Re: Boat Lifts at the Ocean Springs Harbor

SECTION 00901-02
ADDENDUM NO. 2

Project: Boat Lifts at the Ocean Springs Harbor	Owner: Mississippi Department of Marine Resources	Engineer's Project No.: 216-015
--	--	------------------------------------

6 TYPICAL PILE CONNECTION DETAIL
S3.1 SCALE: 1/2" = 1'-0"

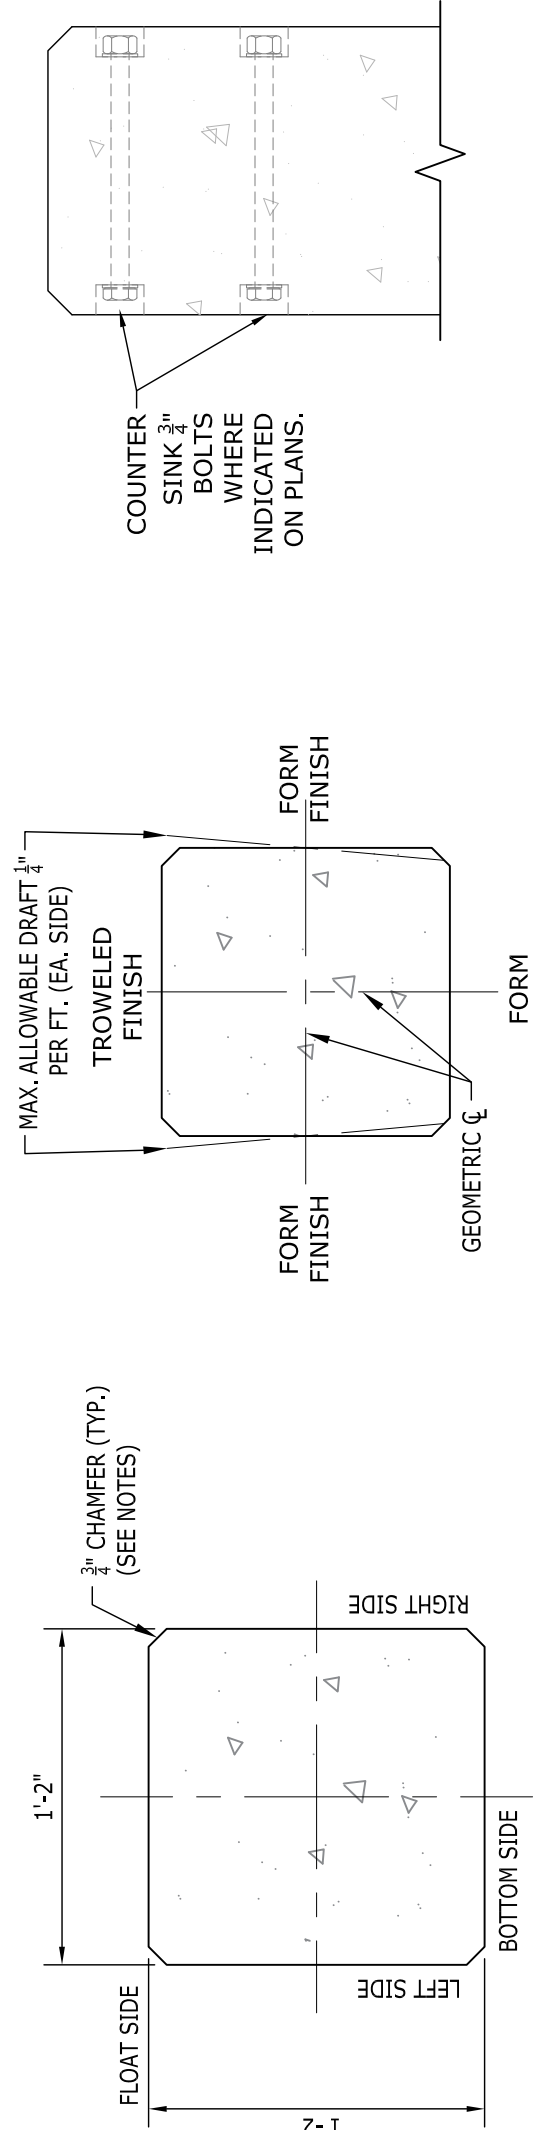
2. SHEET S3.1

Delete Sheet S3.1 in the project manual and replace with **Attachment #2 to Addendum #2.**

Notable Changes:

- a. Pile load tests will not be performed.
